**Bradley Villa, Huddersfield
A641 Bradford Road Site Access Junction and Shepherds
Thorn Lane Ped/Cycle Access**

Response Report to Road Safety Audit Stage 1

July 2022 (Final)

Extract 1: DMRB CD 143 Figure E/5.1N and Table E/5.2

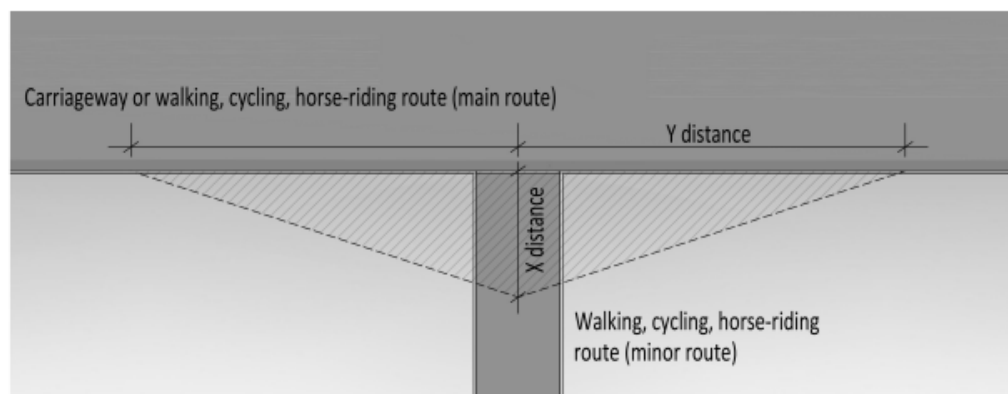
Location: A641 Bradford Road toucan crossing from the western side

Summary: Set back (visibility 'x' distance) of 1.6m for cyclists waiting to cross the A641 is based on a perpendicular arrangement

The Audit Team notes that for cyclists at shared use crossings, the desirable minimum "x" distance is 2.5m as set out in table E/5.2 of DMRB CD 143. This is based on cyclists approaching a main route crossing perpendicularly, this is not the case at the proposed Toucan crossing point.

PROBLEM LOCATION PLAN 2

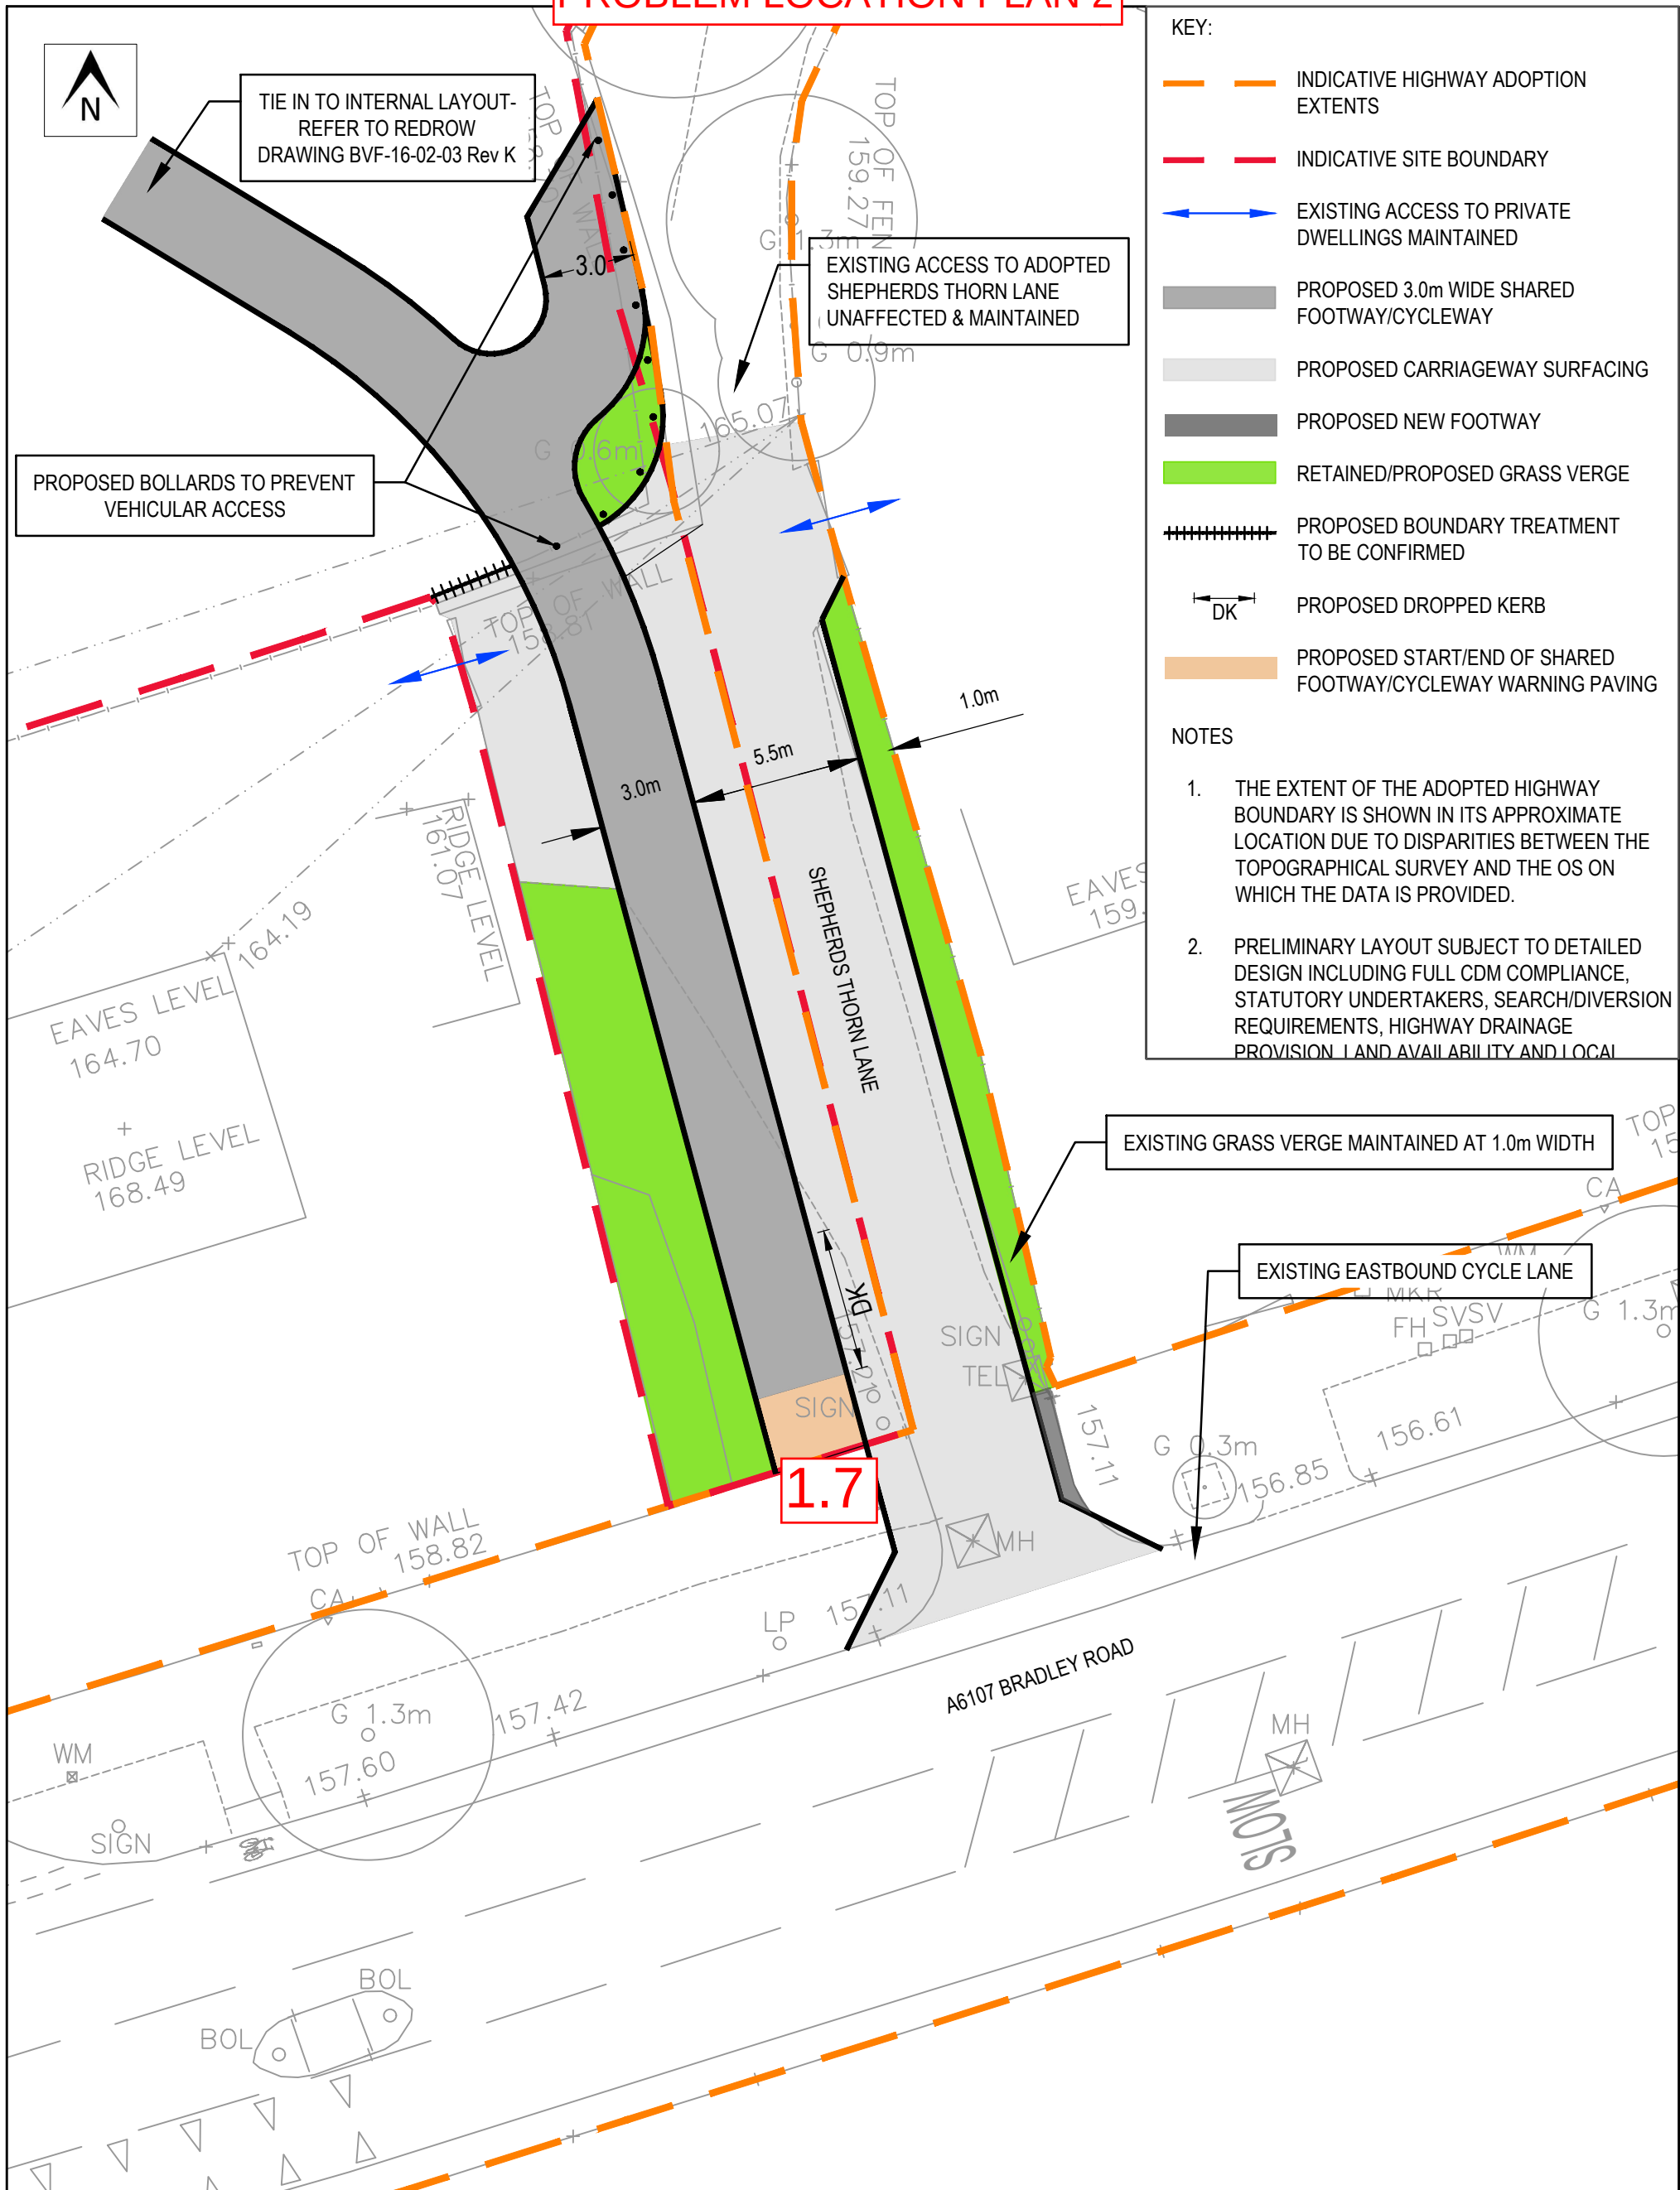
The Audit team noted that the vertical alignment of the A641 Bradford Road north of the proposed site access junction could result in restricted visibility. No information is provided on Drawing No. 19154/GA/01 as to whether the 2.4m x 120m junction visibility splay can be achieved in the vertical plane due the existing crest in the road.

It is recommended that the design team assess whether the visibility to the north from the site access is achievable in the vertical plane or not. If not, then an alternative form of junction control may be necessary.

3.2.1 Problem: Visibility to the right restricted due to vertical alignment, traffic signs, bend in the road Location – Proposed site access junction give-way Summary – Visibility from the minor road is potentially restricted due to the crest of a hill, traffic signs and bend in the road Detail – The Audit team noted that the vertical alignment of the A641 Bradford Road north of the proposed site access junction could result in restricted visibility. No information is provided on Drawing No. 19154/GA/01 as to whether the 2.4m x 120m junction visibility splay can be achieved in the vertical plane due to the existing crest in the road. As a consequence of the above, there is the potential for vehicles exiting the site to be struck by oncoming vehicles travelling at speed if adequate visibility is not provided.	It is recommended that the design team assess whether the visibility to the north from the site access is achievable in the vertical plane or not. If not, then an alternative form of junction control may be necessary. A visibility splay assessment should be carried out (potentially including a speed survey) to establish if adequate visibility is provided.	The RSA recommendation is noted and it is advised that the long sections have already been completed and accepted by the Council after being included within TA Addendum 2 dated April 2022. A copy of the long sections are attached at Appendix F for completeness and show that appropriate visibility can be achieved in the vertical plane.	The long section drawing (19154/IN/03) indicates that a 120m visibility splay is available to the north from the site access, when measured to an object height of 1.05m. However, as with problem 2.1, due to the vertical alignment (crest) of the carriageway, only the tops of cars/bikes will be visible at the full 120m SSD. Therefore, careful siting of any signage or other features in the highway verge/footway to the north of the junction is required, to ensure that the visibility/ conspicuity of the junction is unaffected, with a full review of existing / proposed signage	Careful siting of any signage or other features in the highway verge/footway to the north of the junction is required, to ensure that the visibility/ conspicuity of the junction is unaffected, with a full review of existing / proposed signage required at the detailed design stage, and additional/ amended warning signage and road markings provided as necessary.

Appendix B Optima drawing 19154/GA/04 Revision D

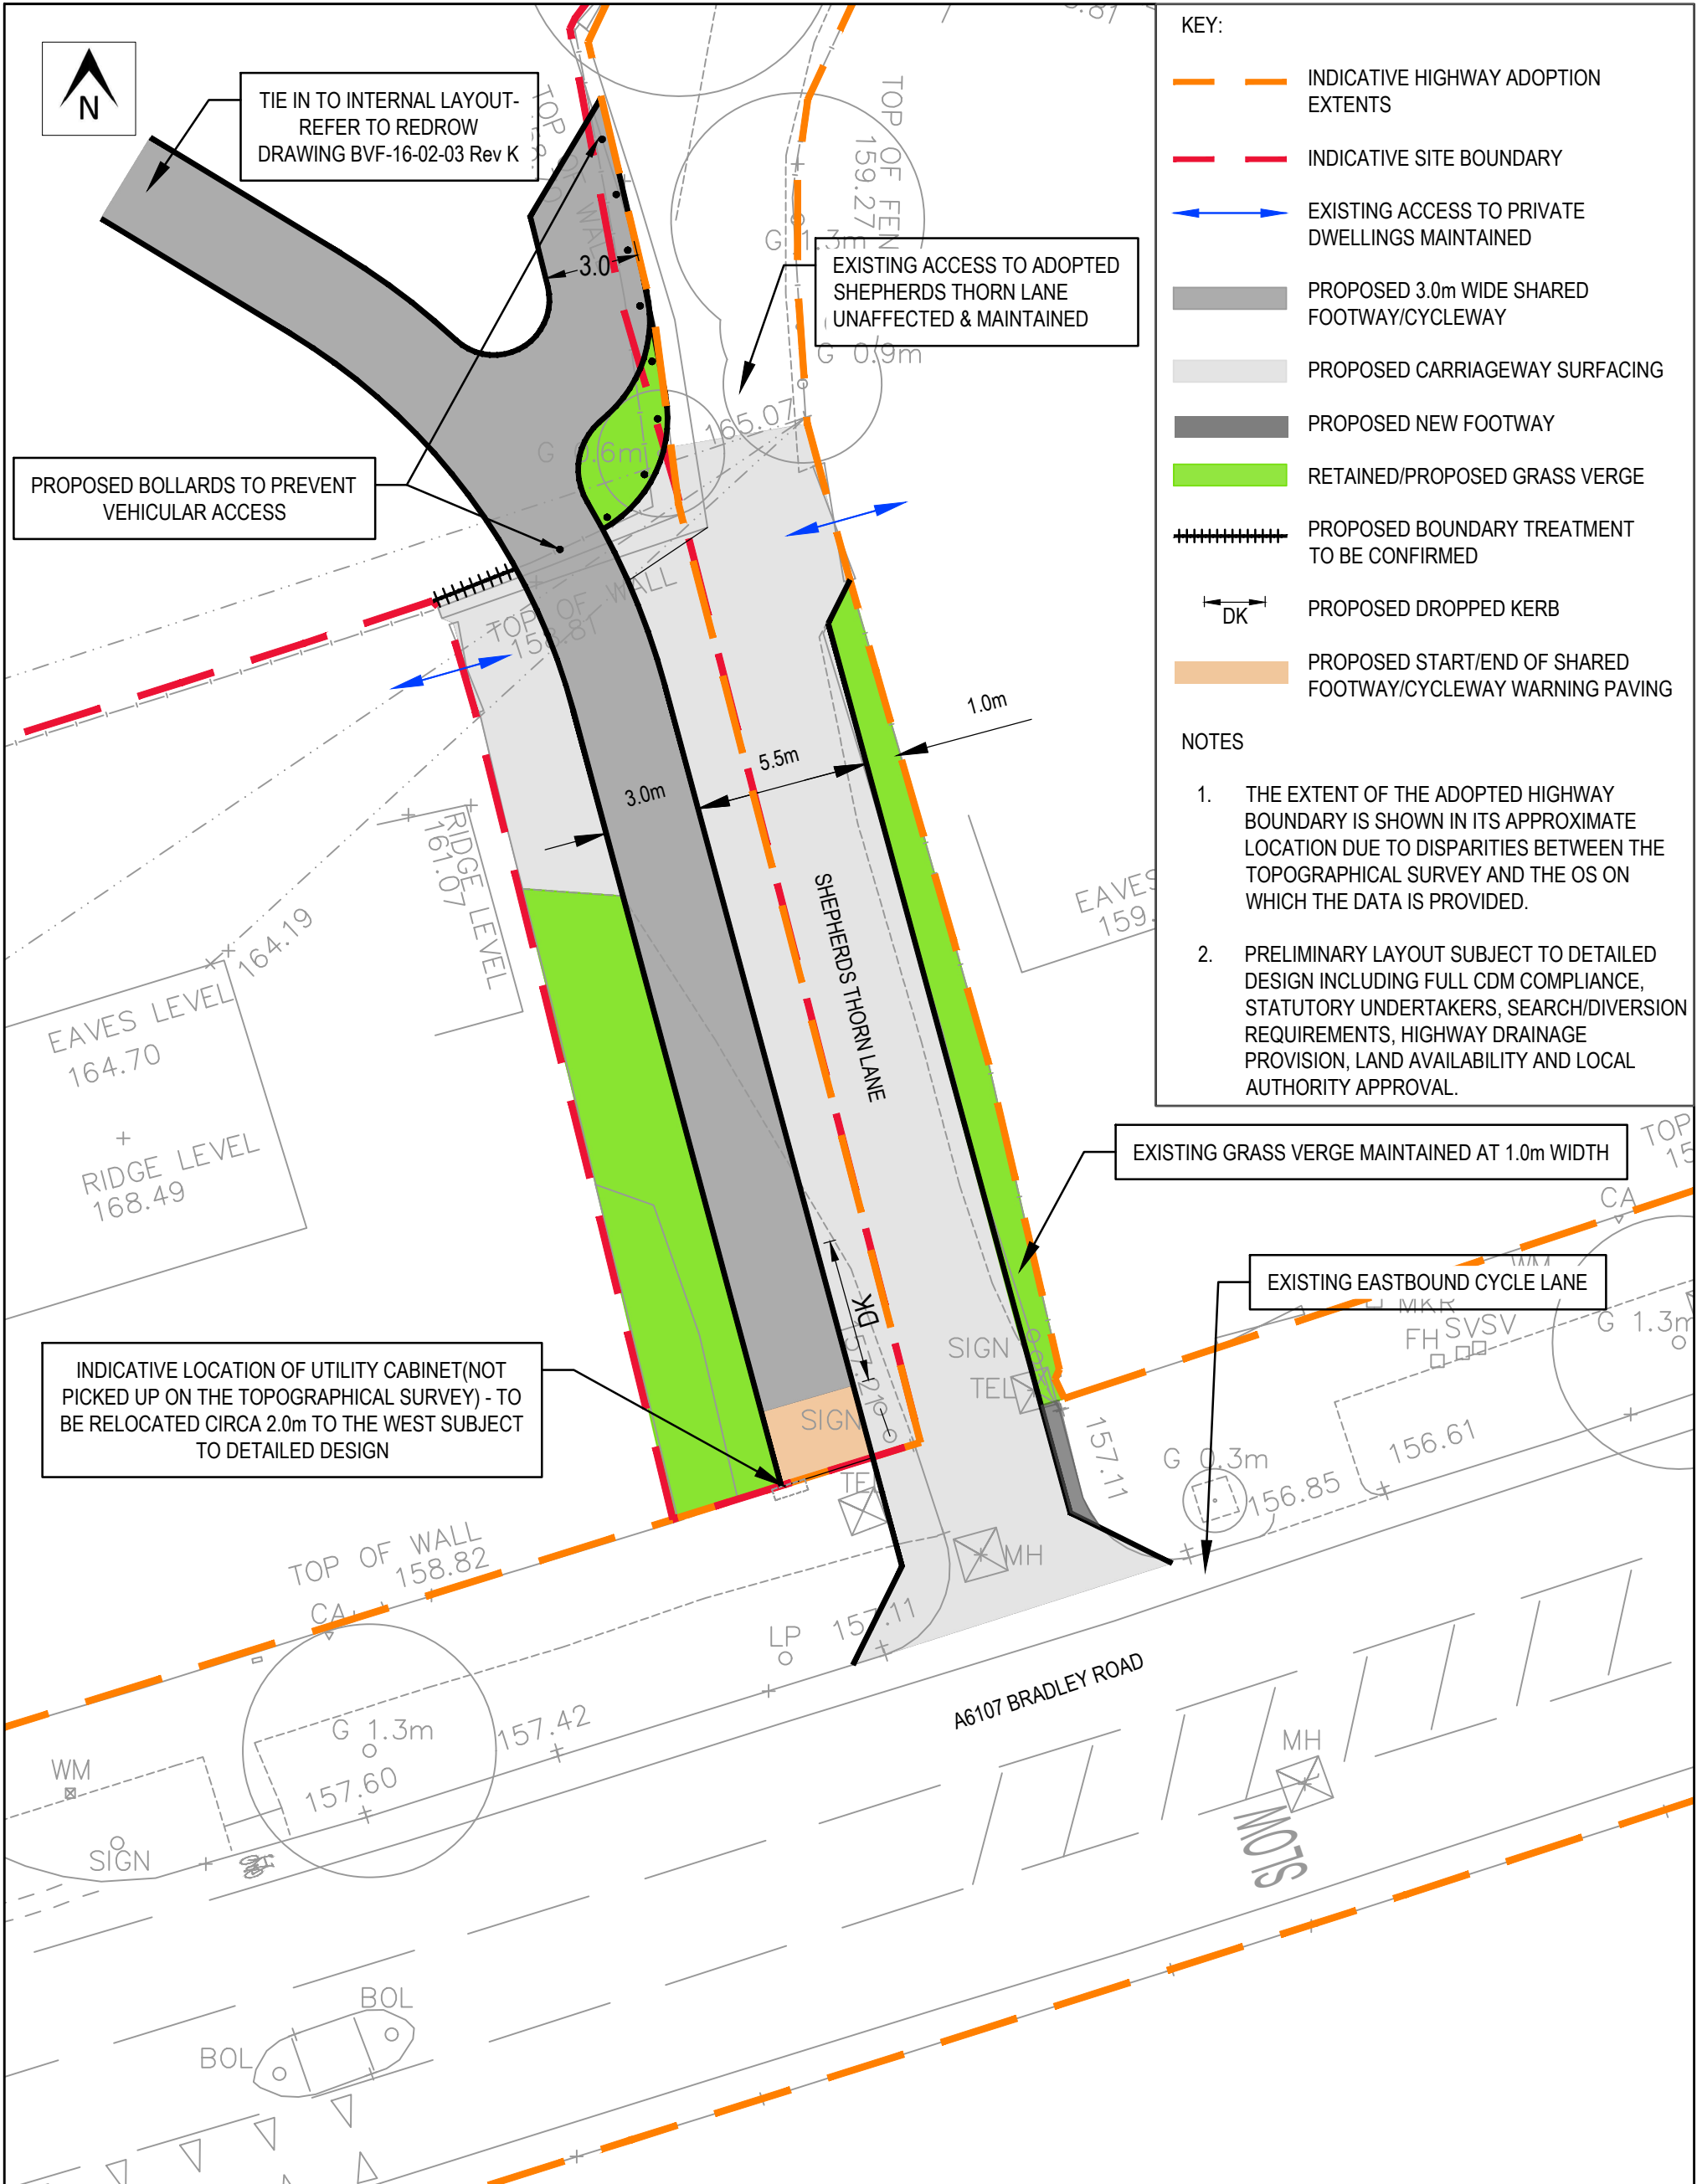
1.7 Problem: Utility cabinet and underground services at the start of shared footway/cycleway warning paving

The Audit team noted that a utility cabinet and underground services chamber is located at the start of the proposed shared footway/cycleway onto Shepherds Thorn Lane. Cyclists turning to use the lane have the potential to strike the cabinet in close proximity, especially if a pedestrian is walking at the same time. Accessing the adjacent underground services chamber may also result in cyclists utilising the proposed Shepherds Thorn Lane carriageway and conflicting with vehicles, albeit vehicular movements here would be minimal.

It is recommended that clarity is provided with regard to the existing position of both services and a detailed assessment carried out as to whether there is scope to move these services away from the start of the proposed shared use path, or the path is relocated to suit.

RSA Problem	RSA Recommendation	Design Organisation Response	Overseeing Organisation Response	Agreed RSA Action
1.7 Problem: Utility cabinet and underground services at the start of shared footway/cycleway warning paving Location – Western flank of Shepherds Thorn Lane adjacent to A6107 Bradley Road Summary – Public utilities/services apparatus at the commencement of a shared footway/cycleway where cyclists would be carrying out a sharp turn. Detail – The Audit team noted that a utility cabinet and underground services chamber is located at the start of the proposed shared footway/cycleway onto Shepherds Thorn Lane. Cyclists turning to use the lane have the potential to strike the cabinet in close proximity, especially if a pedestrian is walking at the same time. Accessing the adjacent underground services chamber may also result in cyclists utilising the proposed Shepherds Thorn Lane carriageway and conflicting with vehicles, albeit vehicular movements here would be minimal.	It is recommended that clarity is provided with regard to the existing position of both services and a detailed assessment carried out as to whether there is scope to move these services away from the start of the proposed shared use path, or the path is relocated to suit. Increase visibility/ prominence of utility cabinet (by ensuring proposed verge vegetation /grass is maintained at low level) so no blind spots are created which potentially lead to conflict points.	The RSA recommendation is accepted, and the indicative location of the utility cabinet has been shown on the drawing attached at Appendix B. A note has also been added to the drawing which confirms that the cabinet is to be moved circa 2.0m to the west at the detailed design stage.	It is agreed that the cabinet must be relocated, with the location to be determined at the detailed design stage.	The utility cabinet is to be relocated and the exact location will be determined at the detailed design stage.
